SERVICE PROCEDURE

18517

DECEMBER 2018

SUBJECT: SAFETY RECALL
Brake Air Line Tubing on certain IC BUS® CE Series school bus models built 25 January 2018 thru 10 October 2018 with feature code 04AZS (4-channel Antilock Brakes [ABS], 4-channel Electronic Stability, and Automatic Traction Control)

Figure 1. Incorrect Routing
1. Synflex tube

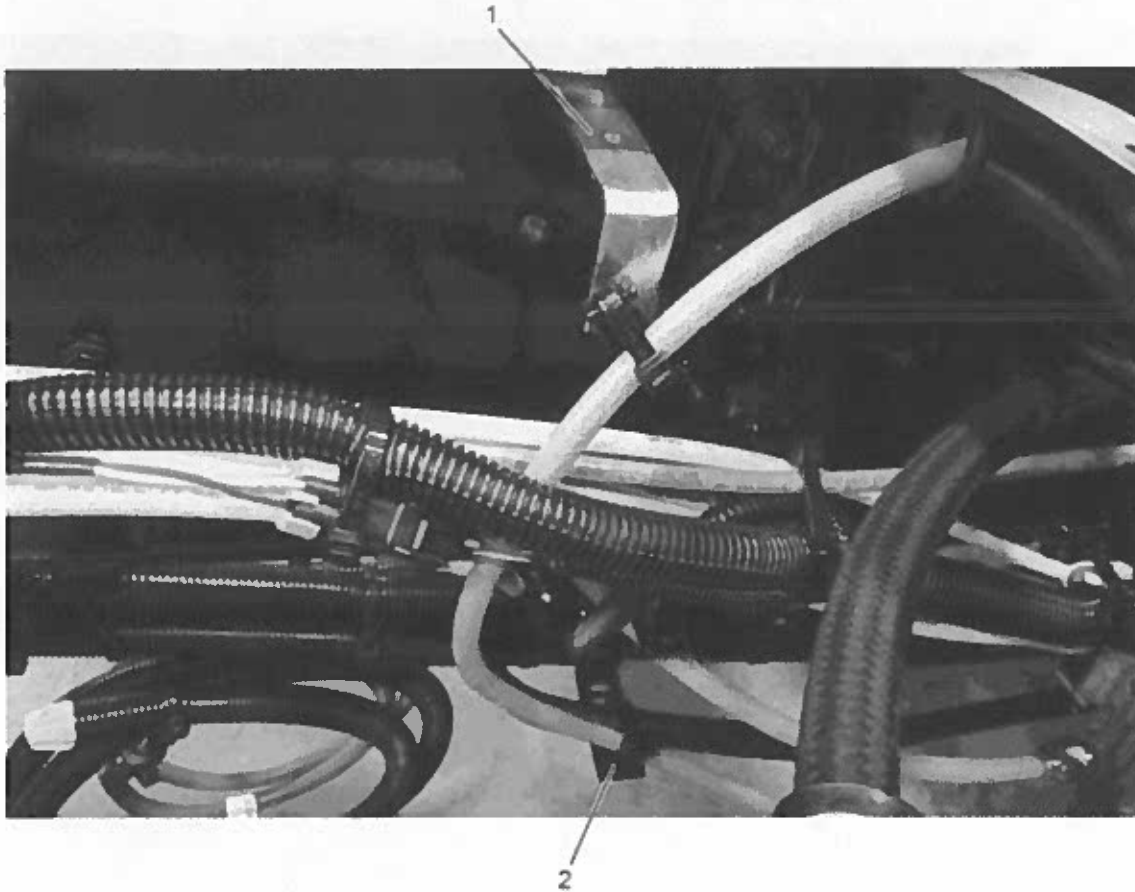
The brake air line tube from the relay valve port to the left brake modulator valve may be improperly routed, resulting in a kinked air line. A kinked air line may result in the vehicle pulling to the right during braking or improper operating of the modulating valve during an ABS event. A vehicle pulling to the right during braking or improper ABS modulation could make it more difficult for the driver to maintain their line, which could result in loss of control or a vehicle crash.

4. Locate and visually inspect Synflex tube. The tube is on the frame rail, near the driver seat area.
 - a. If Synflex tube is routed as shown in Figure 2, proceed to Step 27.
 - b. If Synflex tube is routed as shown in Figure 1, but is free of kinks or damage, proceed to Step 5.
 - c. If Synflex tube is routed as shown in Figure 1 and tube is kinked or damaged, proceed to Step 11.

Figure 7. New Tube Routing

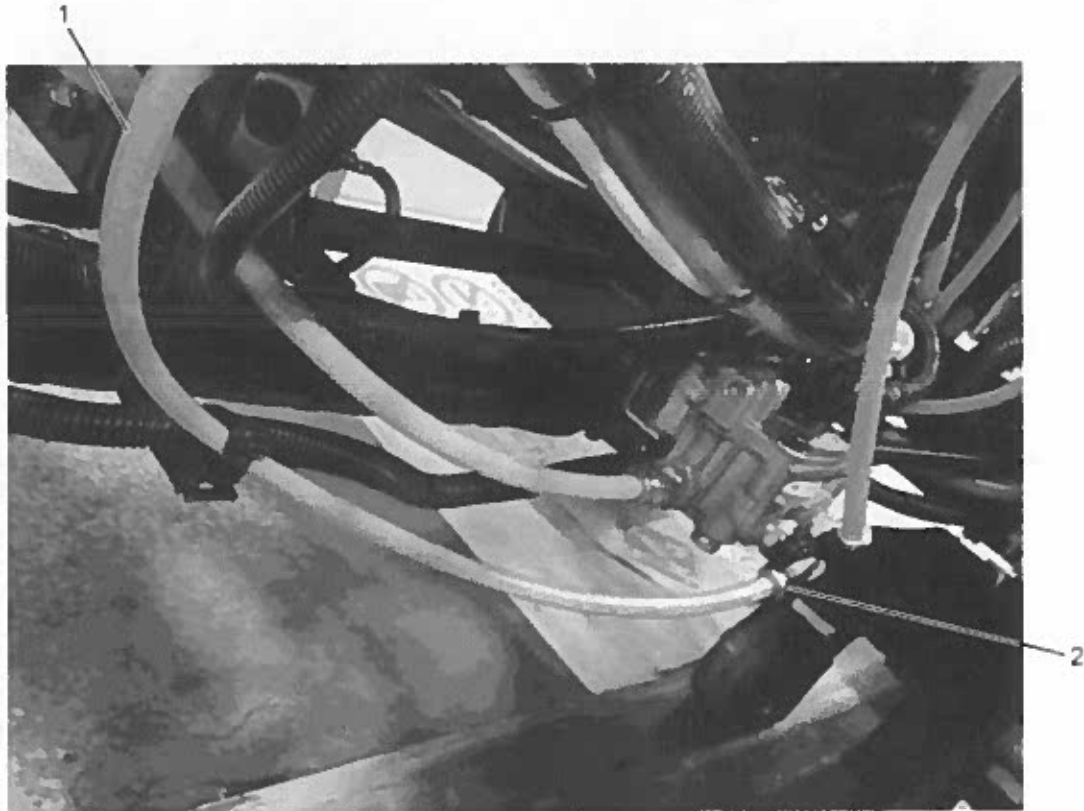
NOTE: It is important to route the airline as shown in Figure 7 and Figure 8. Do not reroute the airline to reduce its length. Shortening the airline will cause the vehicle to pull in one direction when the breaks are applied.

20. Route Synflex tube to Z style extension clip (Item 1) and secure with tie strap.
21. Install new saddle clamp on battery cable ladder bracket (Item 2).
22. Route Synflex tube to battery cable ladder bracket and secure with tie strap.
23. Torque saddle bolt to 90 - 110 lb-in (10 - 12 N•m).
